# Sedan Range

03.1-15

# **TECHNICAL BULLETIN**

Throttle Difficult to Open on Cold Engine – Normally Aspirated Engines – Modify Crankcase Breather System MODEL 1995-97 MY Sedan (4.0L NA) VIN

**ILLUSTRATION 1**

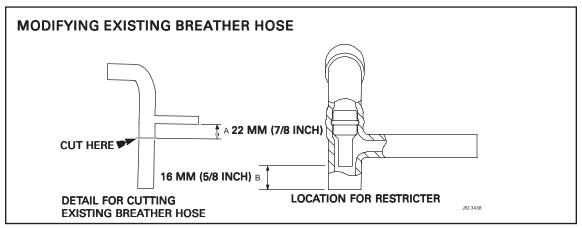
- 15. Cut the existing breather hose as shown in Illustration 1. Make sure that a clean cut is made, maintaining the 22 mm (7/8 inch) dimension consistently.
- 16. Insert the larger diameter of a restricter (Part No. NNB 3956AA) into the cut upper end of the hose. Push the restricter fully into the hose, until the lower end is 16 mm (5/8 inch) from the cut end, as in Illustration 1.

**ILLUSTRATION 2**

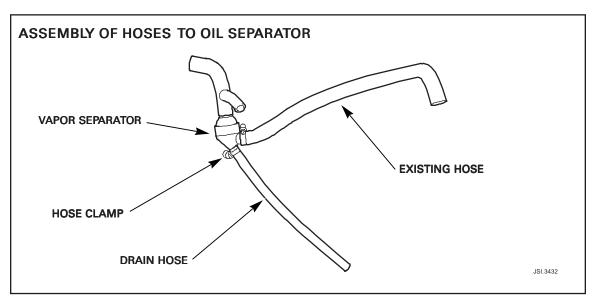
17. Install a worm drive hose clamp (Part No. JHC 200401) and connect the upper portion of the breather hose to the top stub of the oil separator (Part No. NNB 2102AA), as in Illustration 2.

- 18. Installing a worm drive hose clamp (JHC 200401) to the lower portion of the existing breather tube, connect it to the side stub of the oil separator, and with a hose clamp (JHC 200101) install the drain hose (NNB 5961AA) to the lower stub of the oil separator, as in Illustration 2.

- It is important that the worm housing of the hose clamp is installed facing the 'engine' side of the hose and oil separator.
- 19. Tighten the hose clamps with the hoses positioned as in Illustration 2.

**ILLUSTRATION 3**

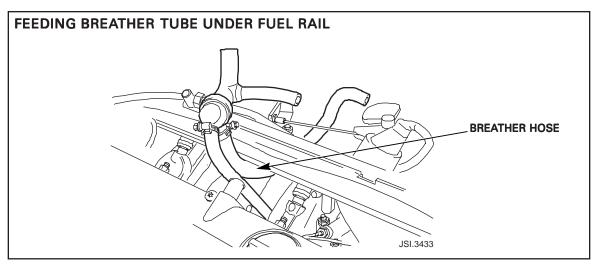
24. As shown in Illustration 3, route the end of the longer breather hose (attached to the side stub of the new oil separator) under the fuel rail. When part-way under the fuel rail, route the thinner drain tube (attached to the bottom stub of the oil separator) between the runners of the intake manifold so that it can eventually be connected to the new dip stick tube.

**ILLUSTRATION 4**

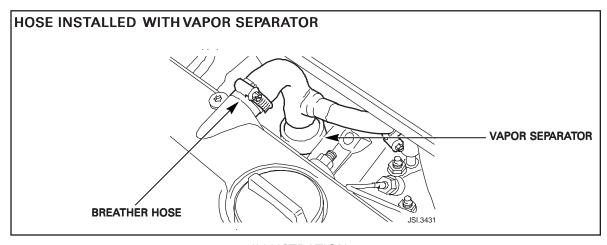
- 25. Continue to align the breather hose assembly until the upper breather hose can be reconnected to the stub pipe on the camshaft cover and the original hose clamp tightened, as in Illustration 4.
- 26. Install the drain hose on the side connection on the replacement dip stick tube, installing a worm drive hose clamp (JHC 200101) over the hose, and tightening the clamp once the hose is fully connected and free of any kinks.
- 27. Check that the dip stick is clean and reinstall it.
- 28. Reinstall the MAFS/induction elbow assembly and reconnect the multiplugs.
- 29. Connect the lower end of the breather hose to the stub on the induction elbow and tighten the hose clamp.
- 30. Reconnect the side hose above the oil separator to its original stub pipe and tighten the hose clamp.
